SERVICE BULLETIN 71 REVISION A MANDATORY

SUBJECT: INSPECTION REQUIREMENTS FOR GLASAIR III ENGINE MOUNTS

FIGURE (1)

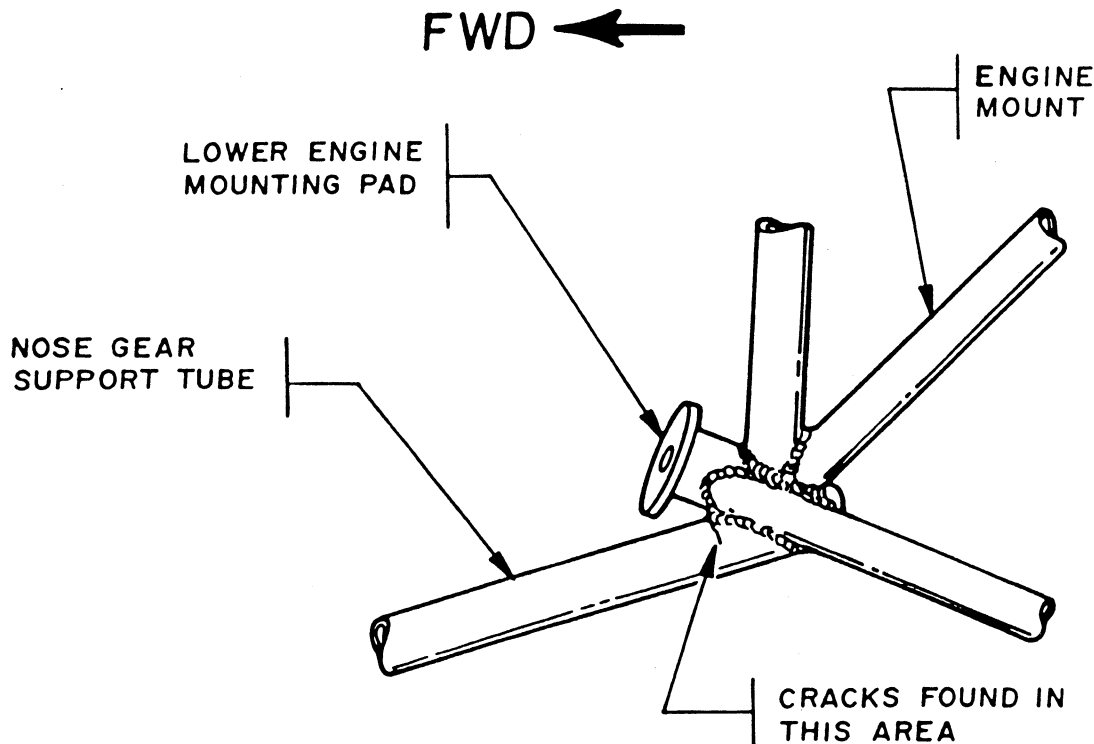
DESCRIPTION: During an inspection of our Glasair III prototype, we found cracks in the engine mount nose gear support tubes. The aircraft has over 950 hours logged with extensive aerobatics over the past three years. The cracks begin at the forward sides of the welds that attach the large nose gear support tubes to the lower engine mount points, as shown in FIGURE (1).

If your Glasair III has accumulated more than 100 hours of flight time, visually inspect the engine mount for cracks in the areas indicated in FIGURE (1).

If cracks are found, please contact Stoddard-Hamilton Aircraft's product support division for a description of repair procedures.

WARNING: If no cracks are found, continue to visually inspect this area every 25 hours or until reinforced per supplement A Revision B to this bulletin, not to exceed 200 hours total time in service.
